# Report of the SCIENTIFIC PEER REVIEW PANEL

ON THE  
DATA, THEORIES, AND METHODOLOGIES  
SUPPORTING THE  
MINIMUM FLOWS AND LEVELS RULE  
FOR THE  
NORTHERN TAMPA BAY AREA, FLORIDA

August 3, 1999

Figure 3. Representative Hydrographs for Reference Lakes

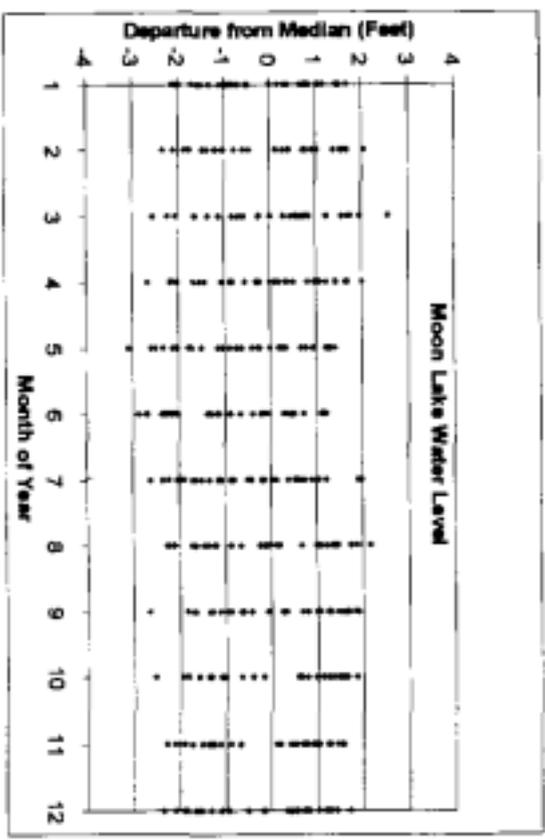
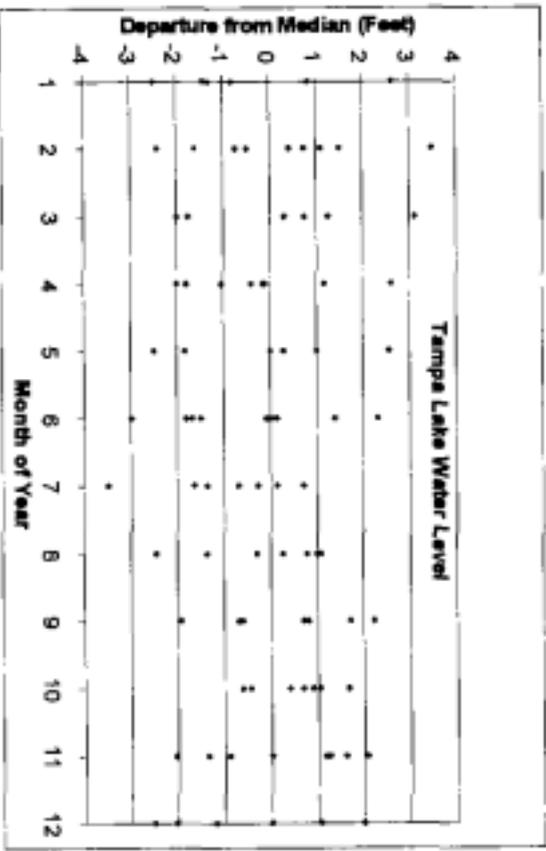
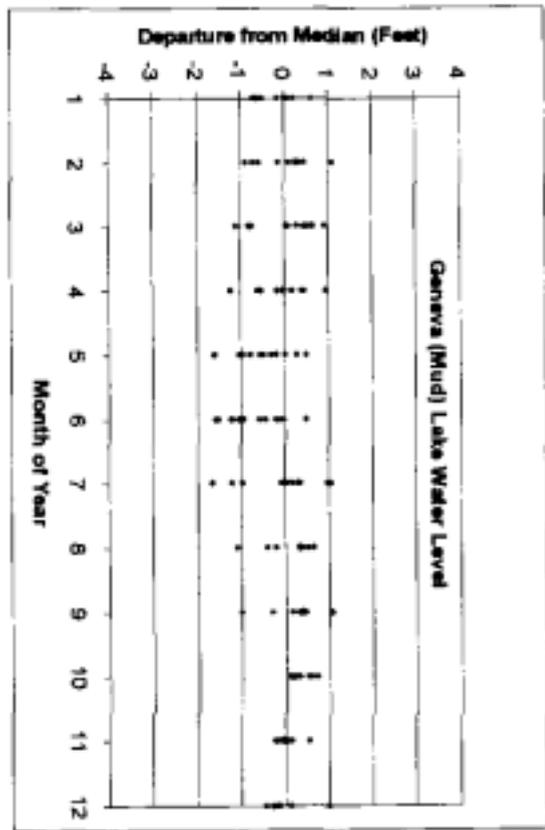
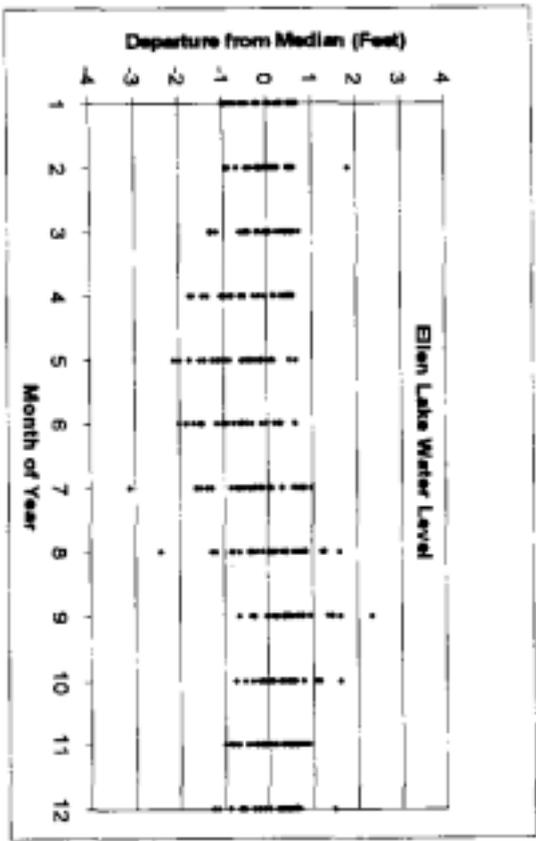
The variability observed in the reference lake data set appears to stem from the position of lakes within the groundwater flow pattern, with some local effects from karst interactions and/or human involvement. Representative patterns in reference lake hydrographs are shown in *Figure 3*, which depicts multiple years of data for water-level departure from the median over the 12 months of the year. The general pattern of early spring and late summer peaks, with a late spring-early summer minimum, is evident. The range of values for a given month is striking, however, when the individual graphs in *Figure 3* are compared. Reasonable interpretations of this variation would include differential linkage to the water table and location along a gradient of groundwater recharge through discharge. Although there is distinct variability within geographic areas, assessment of groundwater flow patterns (see Section 3.3) suggests that positioning within areas of greater or lesser difference in head between surficial and Upper Floridan aquifers may explain much of the variability across geographic areas. Creation of separate reference lake classes might, therefore, be justifiable and could alter the assigned RLWR in a meaningful way.

The P10-P50 and P10-P90 values, essential to establishing the RLWR, are summarized for each group in Table 12. The similarity between the values for Groups 1 and 2 and also between values for Groups 3 and 4 is striking, and suggests that only two classes of reference lake are needed from a functional perspective. There may be other differences between these lake groups that bear further inspection, and the Panel has chosen to leave the four groups separate for illustrative purposes. One lake from each group is represented in Figure 3.
